Re: Interpretation for SP 2007-LE-122 and VC 2007-LE-004, Trustees of Laurel Grove Baptist Church, 6834 Beulah Street, Tax Map 91-1 ((1)) 25: Building Addition

Subject: Interpretation Request; SP 2007-LE-122, VC 2007-LE-004

Exhibit 1.
 Sketch Plan. 1"=20'
 WKA, Inc. 6-5-08

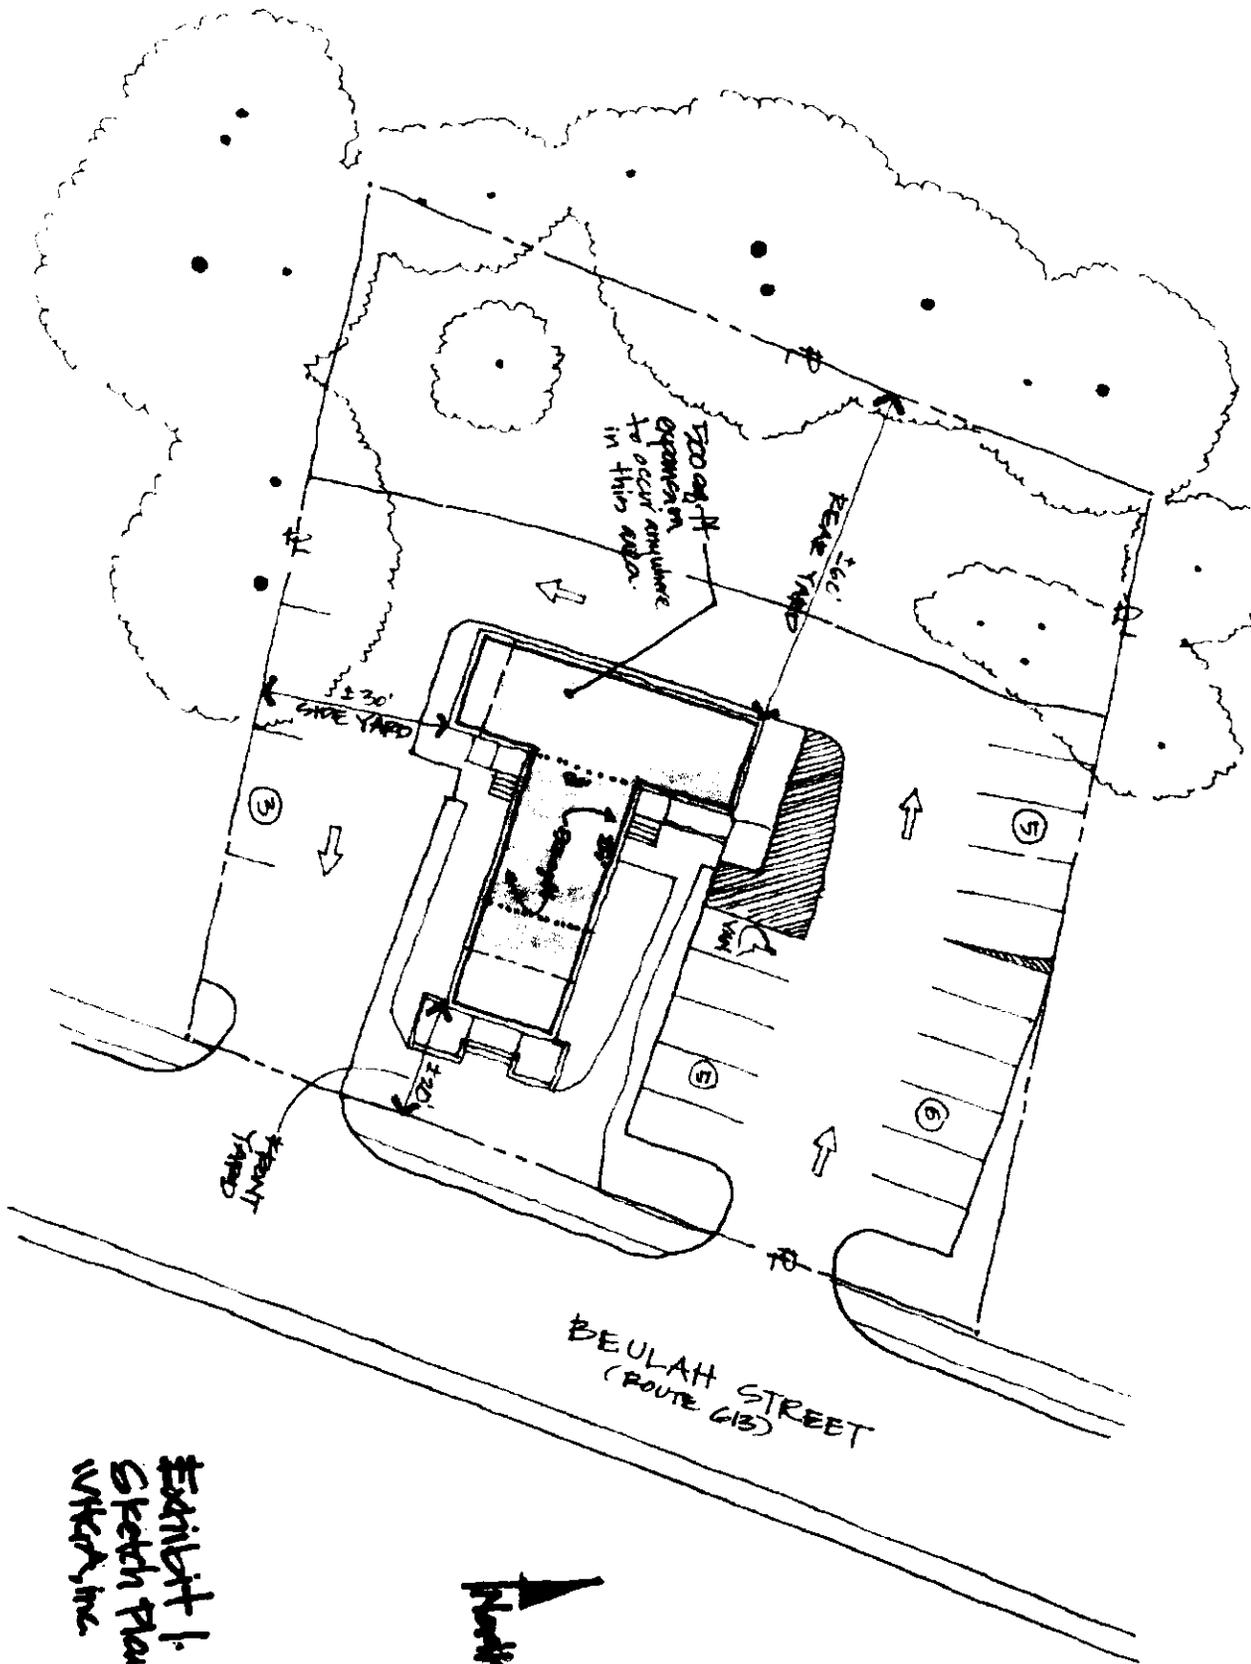
Based on the above, the proposed addition of 500 square feet may be permitted as a minor modification; however, as I understand it, the proposed addition would increase the building height from 25 feet to 35 feet, which would add bulk above the approved height.

As such, it is my determination that the proposed building addition described above and in your submission is not in substantial conformance with SP 2007-LE-122 and VC 2007-LE-004. This determination has been made in my capacity as the duly authorized agent of the Zoning Administrator. If you have any questions regarding this interpretation, please feel free to contact Mary Ann Godfrey at (703) 324-1290.

Exhibit 2
Bulk Plane Angles
IVHGA, inc. 6.15.08

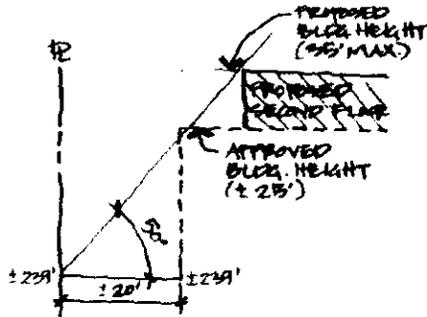
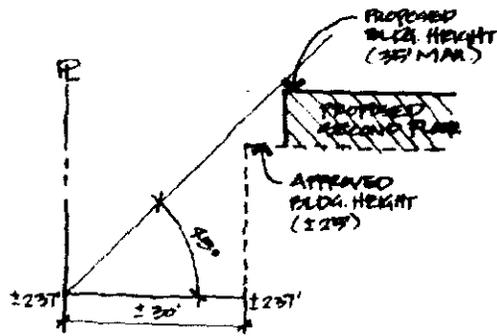
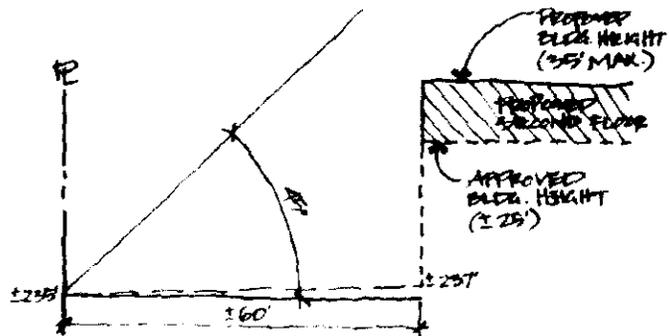
Paragraph 4B. (5) of Sect. 8-004 states that modifications shall in no event "*Permit changes to bulk, mass, orientation or location which adversely impact the relationship of the development or part thereof to adjacent property.*"

- (4) Reduce the effectiveness of approved transitional screening, buffering, and landscaping or open space; or **(no change)**
- (5) Permit changes to bulk, mass, orientation or location which adversely impact the relationship of the development or part thereof to adjacent property; or **(changes do not adversely affect adjacent properties and meet bulk plane angles, see attached Exhibit 2)**
